SUBJECT: ISSUANCE OF AMENDMENT NO. 149 TO FACILITY OPERATING LICENSE NO. DPR-62 - BRUNSWICK STEAM ELECTRIC PLANT, UNIT 2, REGARDING FUEL CYCLE NO. 8 - RELOAD (TAC NO. 66155)

BRUNSWICK STEAM ELECTRIC PLANT, UNIT 2

Amendment No. 149 License No. DPR-62

SAFETY EVALUATION BY THE OFFICE OF NUCLEAR REACTOR REGULATION SUPPORTING AMENDMENT NO. 149 TO FACILITY OPERATING LICENSE NO. DPR-62 CAROLINA POWER & LIGHT COMPANY, et al.

Figure 3.2.1-3

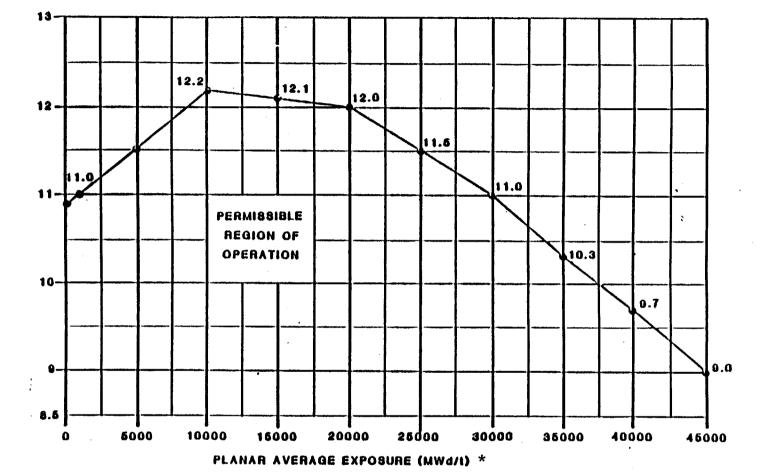
MAXIMUM AVERAGE PLANAR LINEAR HEAT GENERATION RATE

FUEL TYPE BP8DR8209 (BP8x8R)

MAXIMUM AVERAGE PLANAR LINEAR HEAT GENERATION RATE (MAPLHGR) VERSUS AVERAGE PLANAR EXPOSURE

*Amendment 149 _____ authorizes operation only up to an average fuel bundle burnup of 33,000 MWD/MT

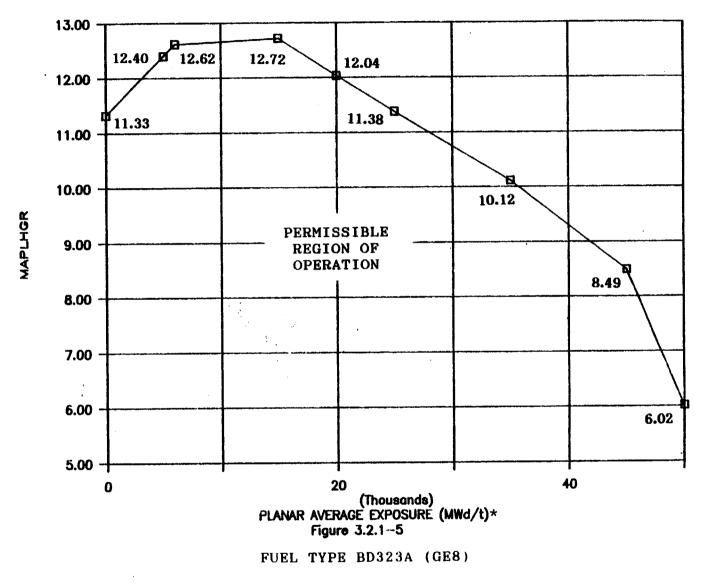
hand calculations. The limiting values for each lattice are in the core monitoring system.

*Amendment <u>149</u> authorizes operation only up to an average fuel bundle burnup of 33,000 MWD/MT
